Value Engineering Study Report – Final

I-69 Ohio River Crossing Project Evansville, IN and Henderson, KY

August 2, 2019

VALUE ENGINEERING PROPOSAL NO. SR-14

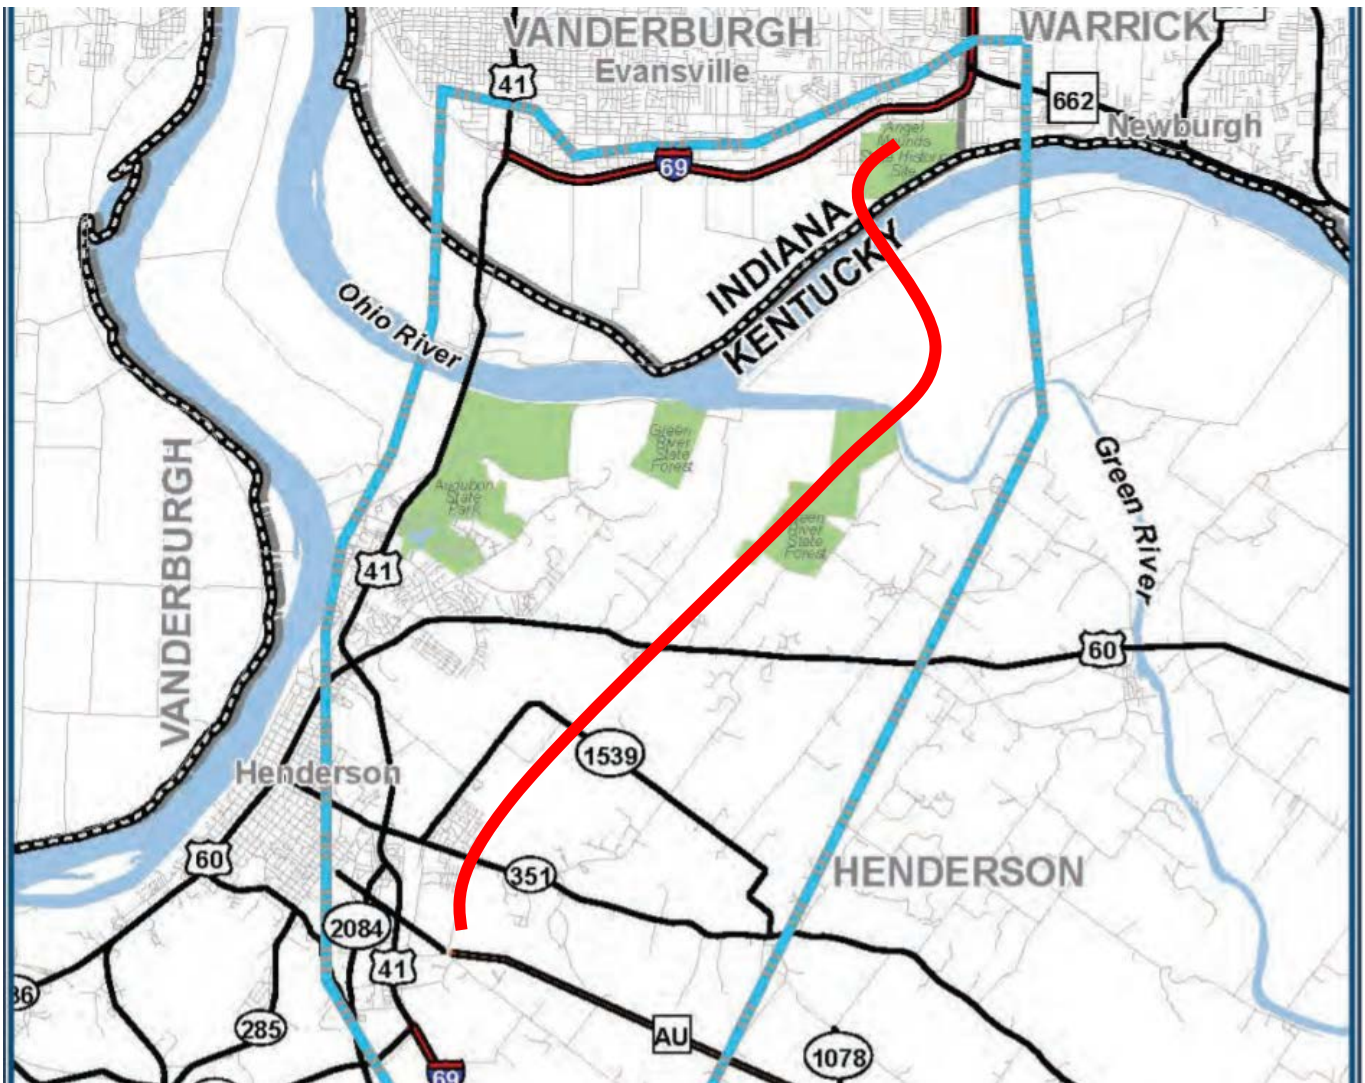
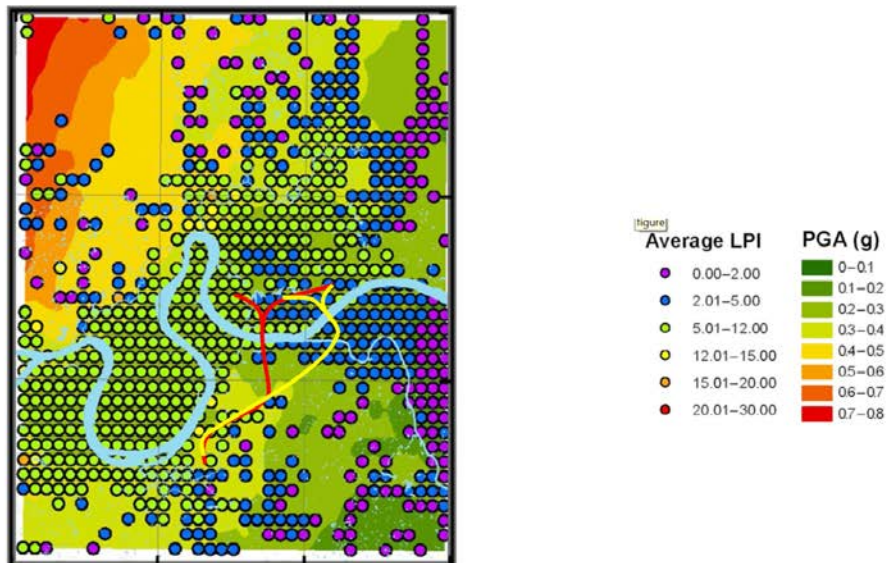
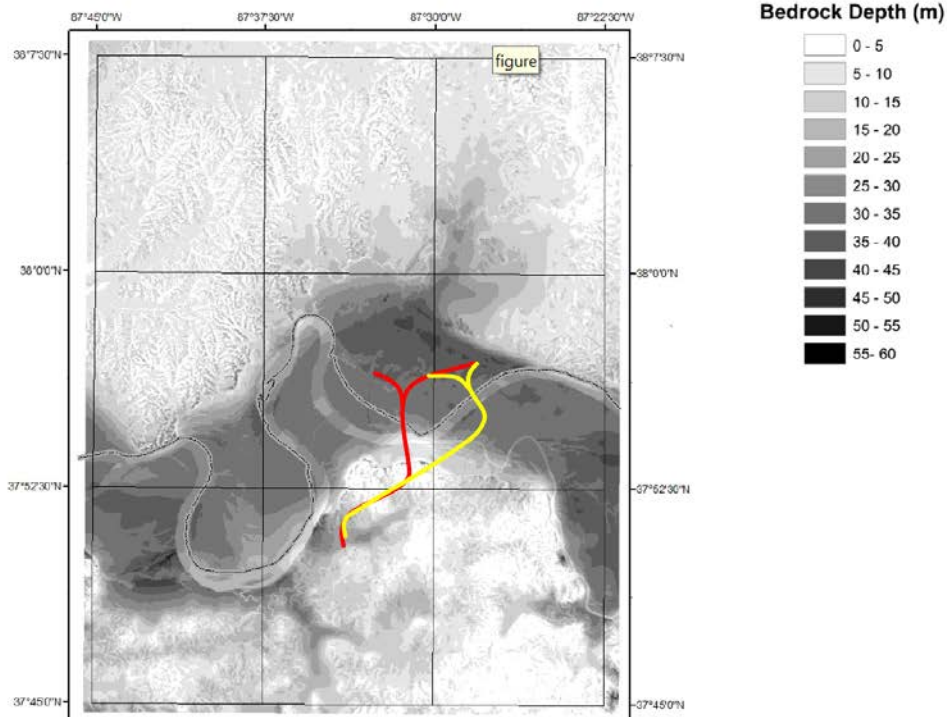
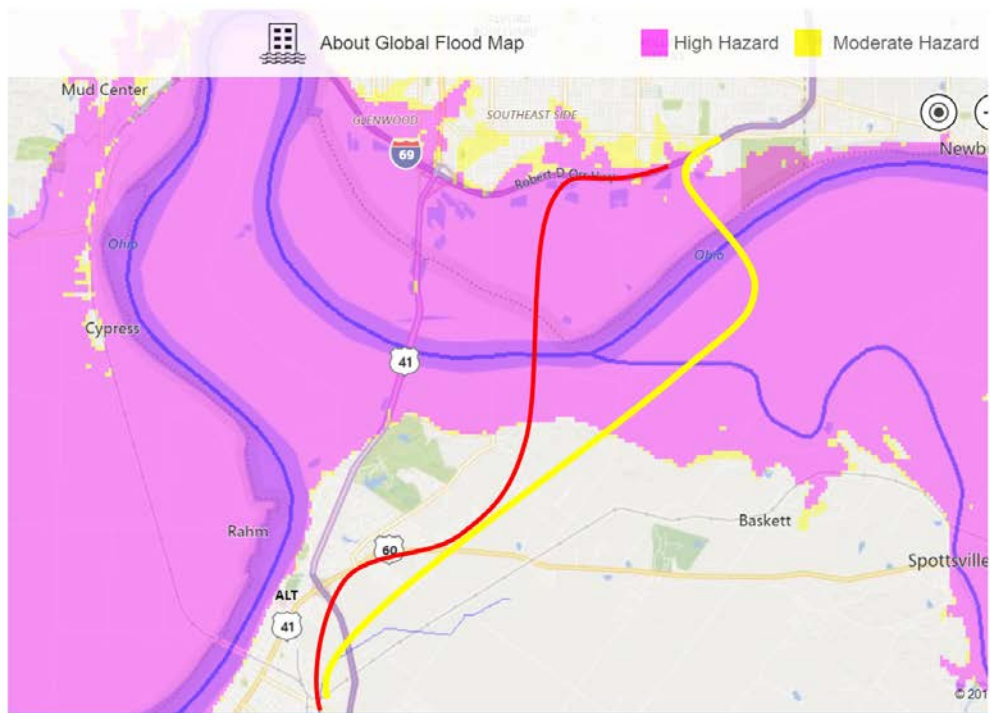
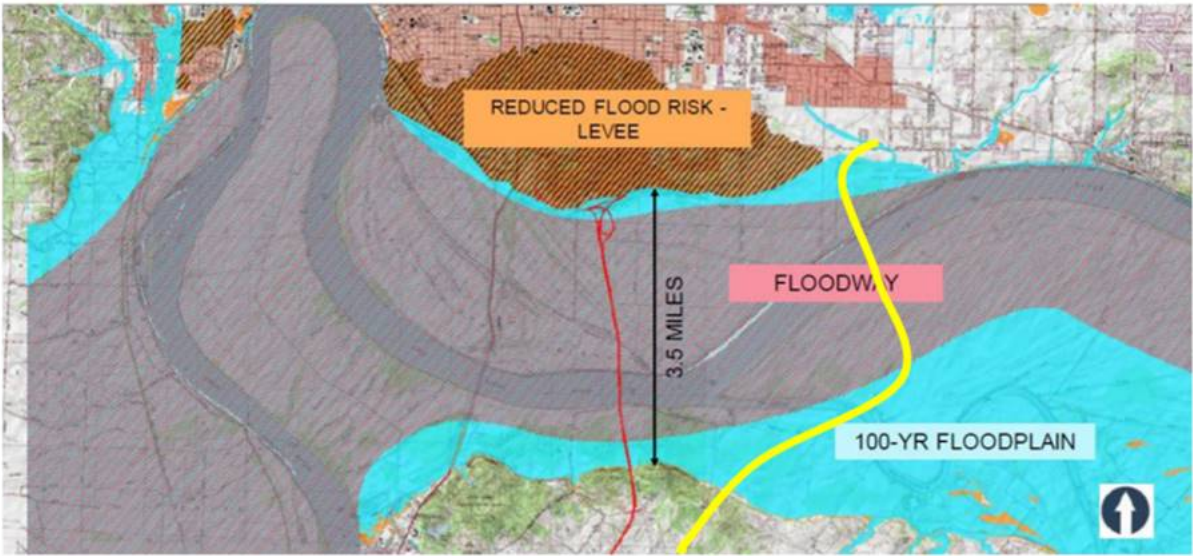
The alternative concept modifies the location of the east crossing to span the Ohio River just to the west of the Angel Mounds Site. This requires a separate crossing of the green river and splits the two Green River Forest parcels but avoids all the Indiana residential relocations in the eastern corridor and significantly reduces right of way costs. A primary benefit of this alignment is that it reduces to the extent possible, the portion of the river crossing over Indiana and therefore reduces the hydraulic impacts where Indiana has more stringent requirements.

SCHEDULE IMPACT:	<p><u>Rough order of magnitude impact to construction schedule (reduction) 180 Days, note potential negative impact to EIS schedule of 1 year+</u></p> <p>Given that a significant portion of the proposed alignment is not in the floodway as compared to the proposed alignment, there is significantly less schedule impact due to flooding during foundation construction. Foundation construction in the floodway represents a significant schedule risk to the project.</p>
ALTERNATIVE CONCEPT DISCUSSION / JUSTIFICATION:	
<p>This alternative is a modification to the east corridor alternative, with the alignment shifted to the west of the Angels Mounds State Historic Site. More importantly, it moves the river crossing to a location in the river where there is no bend, and moves the crossing away from the confluence of the green river, where there is significant fleeting and loading/unloading activity. This location will substantially reduce the likelihood of vessel collision risk, and with a navigation simulation, likely reduce the requirements for main span length. The overall length of the water crossing, as well as the total area of bridge in the floodplain, is not significantly different from the central corridor.</p> <p>Also, there has been a liquefaction lateral spreading risk assessment for Evansville completed by Purdue University, which highlights the sensitivity of the Indiana floodplain to liquefaction and lateral spreading. This can negatively impact foundation costs (these impacts could be significant depending on degree of lateral spreading and liquefaction). A liquefaction risk potential map has been included with the central and proposed eastern alignment overlaid to give a sense of relative risk. As an aside, the existing US 41 bridge alignment is in the worst part of the corridor, and in a seismic event for historic structures not designed to resist seismic loads. Significant damage to the existing bridge in a major seismic event is likely.</p> <p>Depth to sound bedrock also correlates with foundation costs for major bridges, and the proposed easterly alignment puts a significant portion of the bridge in areas where bedrock is relatively shallow which should reduce foundation costs and construction schedule / risk.</p> <p>Deep foundations which require heavy equipment and complex logistics are reduced to the extent possible in the floodplain, so that flood impacts to construction activities (particularly foundation construction) will be minimized. The portion of the alignment in the floodway has been significantly reduced where the likelihood of flood risk during construction is the highest.</p> <p>In terms of implementation, a major issue is that this revises the preferred alternative in the draft EIS and would either require a supplemental draft or has the potential of delaying completion of the environmental process. It also requires a re-evaluation of the navigational requirements at this location, as well as interchange design work in Indiana. Estimated time impact (delay) to the environmental process is 1 to 2 years. Also, it will be important in the near term to coordinate with the proposed Green River National Wildlife Refuge for an alternate corridor, or corridor flexibility for the revised alignment, before the EA is finalized.</p>

VALUE ENGINEERING PROPOSAL NO. AC-01

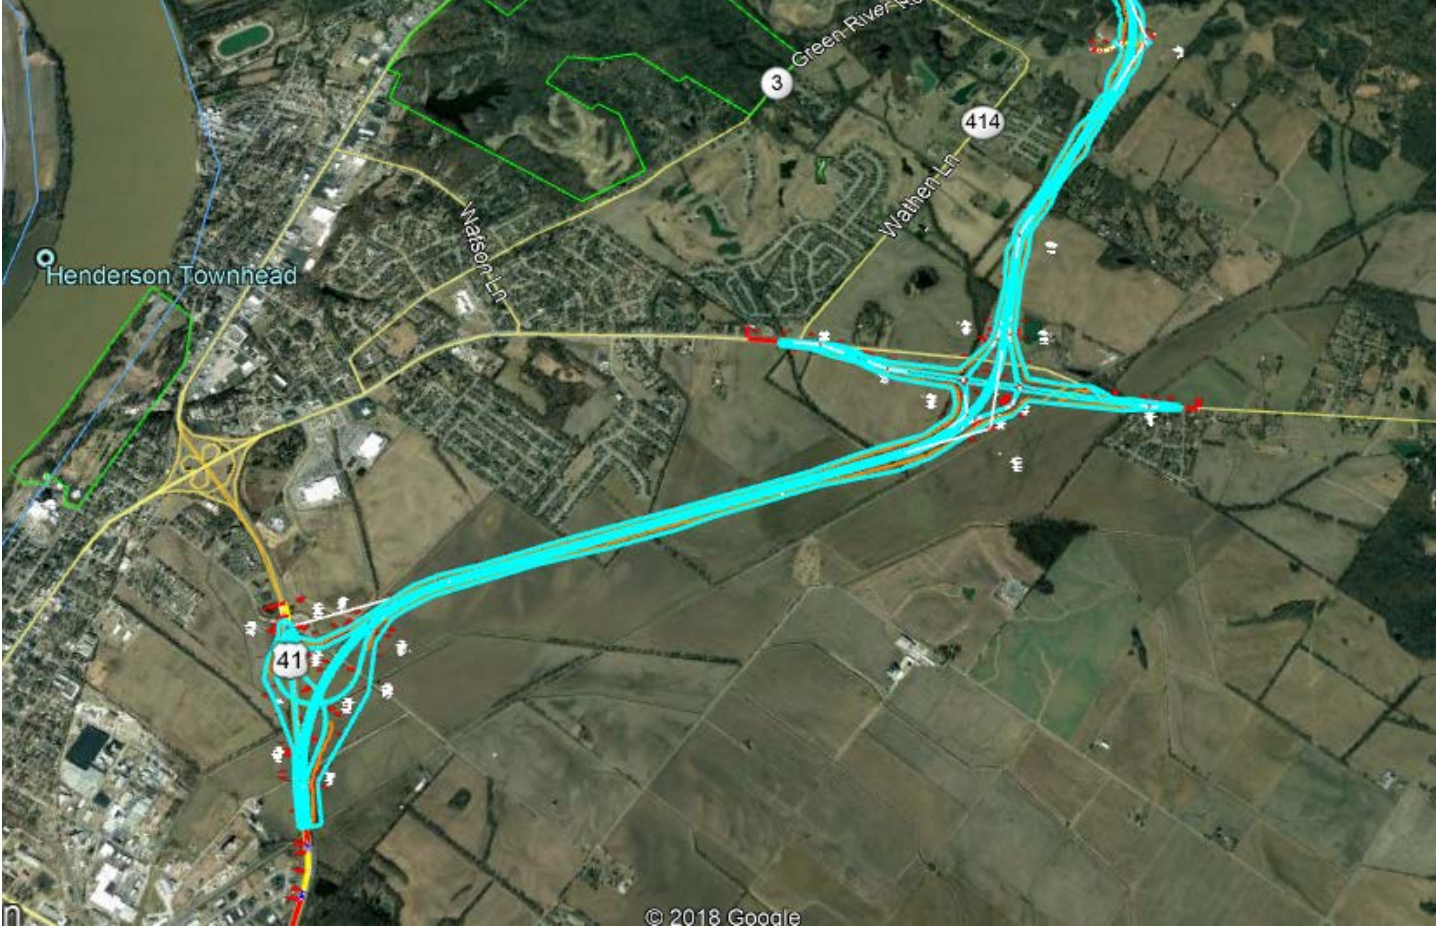
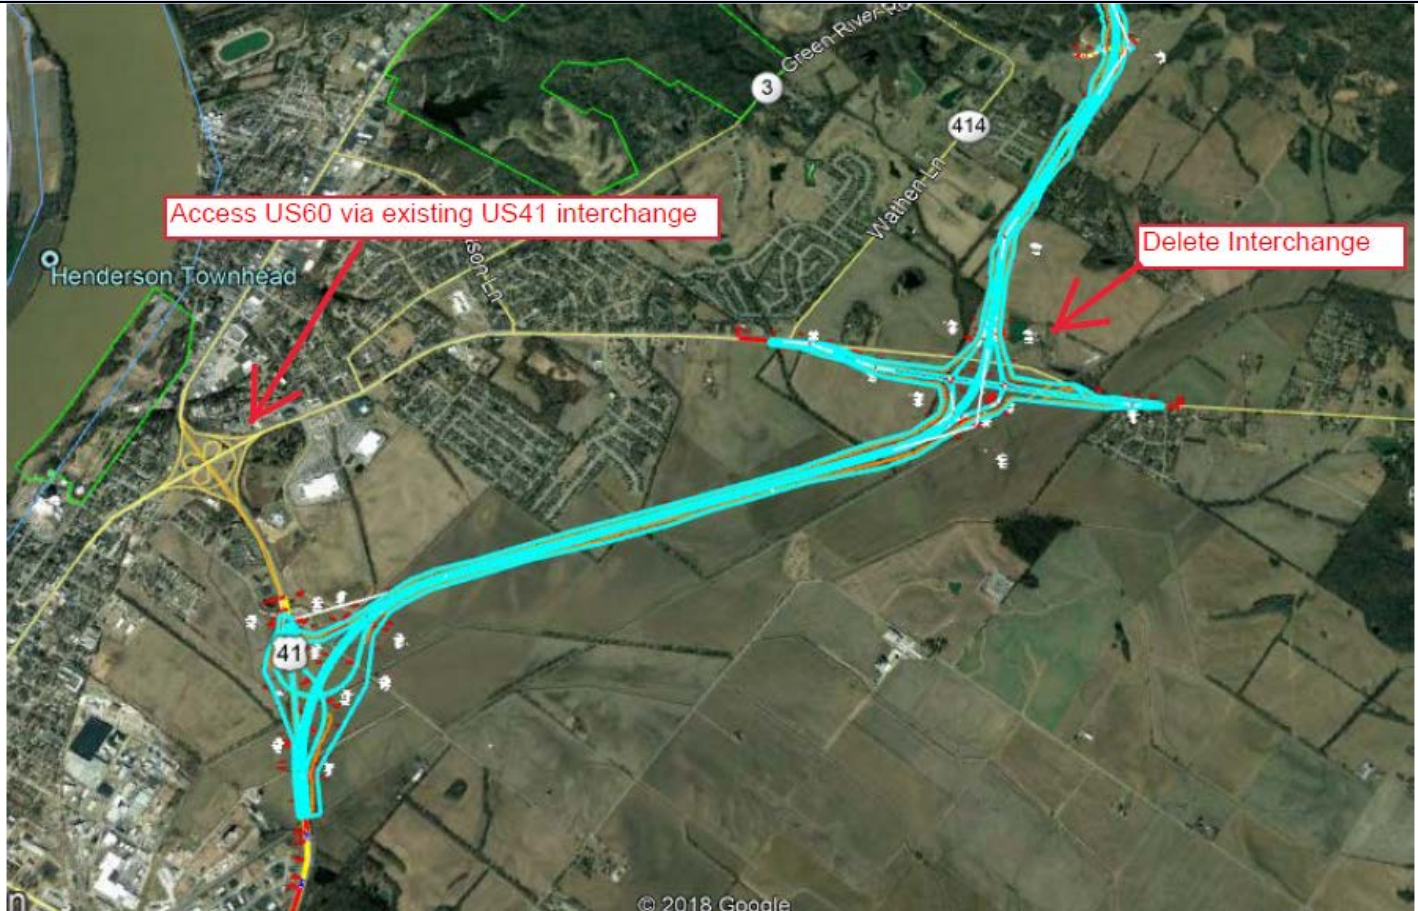
Rough order of magnitude impact to cost (potential cost avoidance) - \$5M
Reduce cost by roughly the same number as for SR-06, Remove US 60 interchange.

Rough order of magnitude impact to schedule (reduce schedule) – 3 months
Same schedule savings as SR-06, Remove US 60 interchange.

VALUE ENGINEERING PROPOSAL NO. AC-02

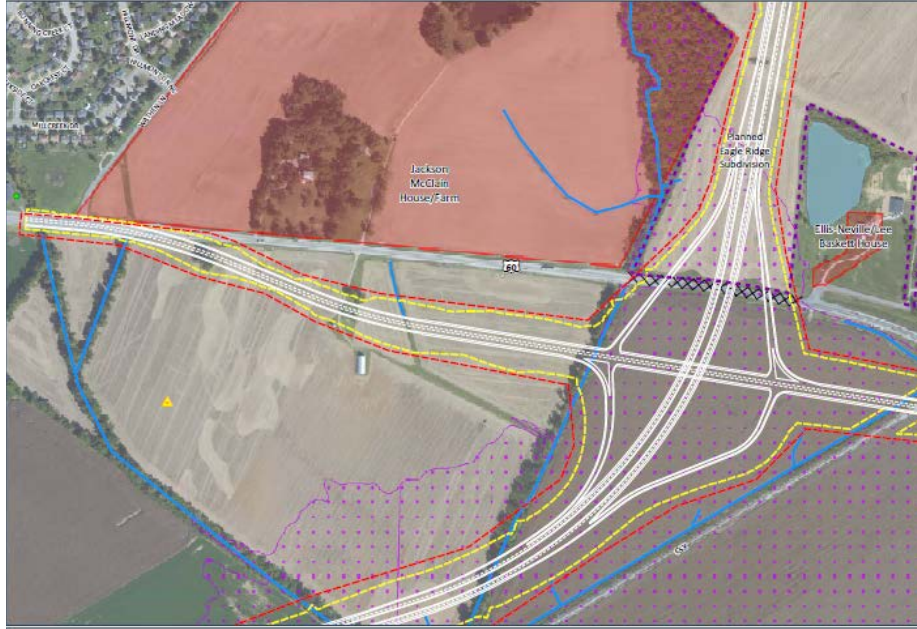
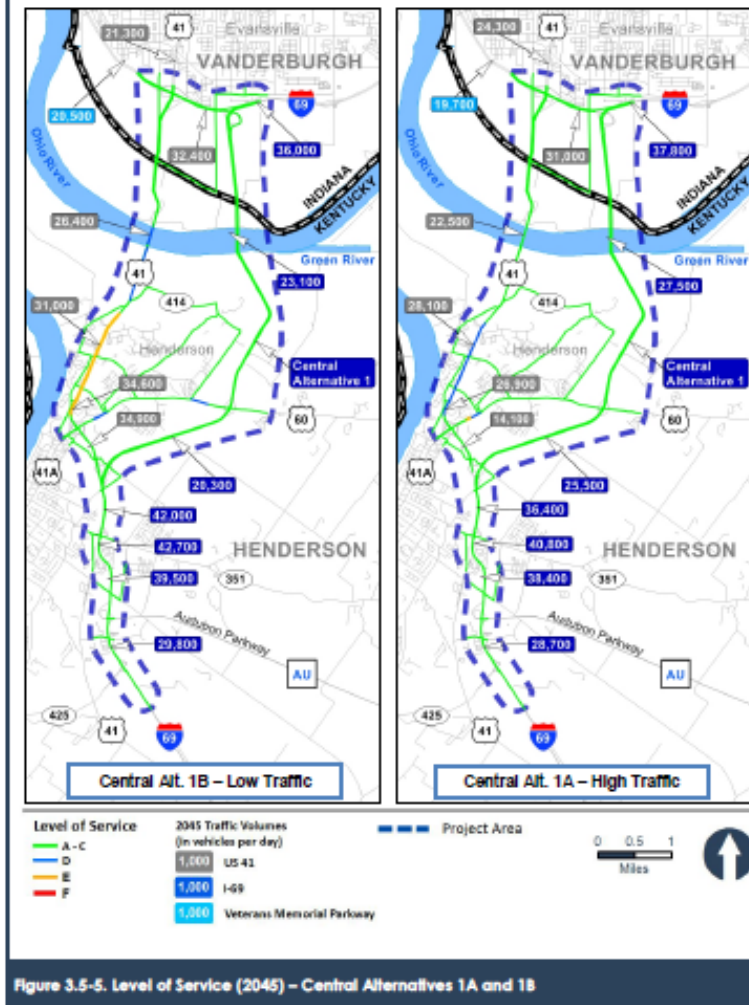
The Alternative Concept proposes to either “collapse and/or combine” the US 60 and US 41 interchanges currently proposed under the Preferred Alternative into either one interchange or possibly into two partial interchanges. This reduces cost through the elimination of non-critical movements, and therefore access ramps and potential structure modifications, based on traffic demand needs and an aim to reduce redundant movements in proximity to one another. Since the proposed US 60 interchange is currently classified as a “service interchange” and the US 41 is classified as a “system interchange” it would be more practical to eliminate the US 60 interchange (refer to proposal SR-06, Remove US 60 interchange) or reduce access and provide main access to US 60 via US 41 to be confirmed via O/D analysis.

Based on a refinement of the traffic analysis (origin/destination survey), it is proposed that the interchanges of US 60 and US 41 with the proposed alignment of I-69 be reviewed to determine which movements should be accommodated as critical movements and which movements should be eliminated or provided for in the future (where practical). This reconfiguration would provide a cost savings to the currently proposed baseline project (Central Alternatives 1A and 1B I-69 Alignment). As current traffic data is not available at this time, the approach of this concept is to point out the potential “cost targets” that make up the estimated construction cost of the various ramps and structures that could be either eliminated or reconfigured – approximately \$21M. The total cost savings would depend on the elimination/reconfiguration of ramps and the reduction of structural costs based on the interchange refinements.

1. Elimination of US 60 interchange; keep the proposed US 41 interchange as proposed.
2. Elimination of US 60 interchange; reconfigure ramps at US 41 to provide free flow high volume movements to I-69; reconfigure ramps to US 41 (and other connections) to minimize cost.
3. Reconfigure both US 60 and US 41 interchange ramps to provide necessary access based on O/D analysis (potential for partial interchanges at both locations) related to critical movements.
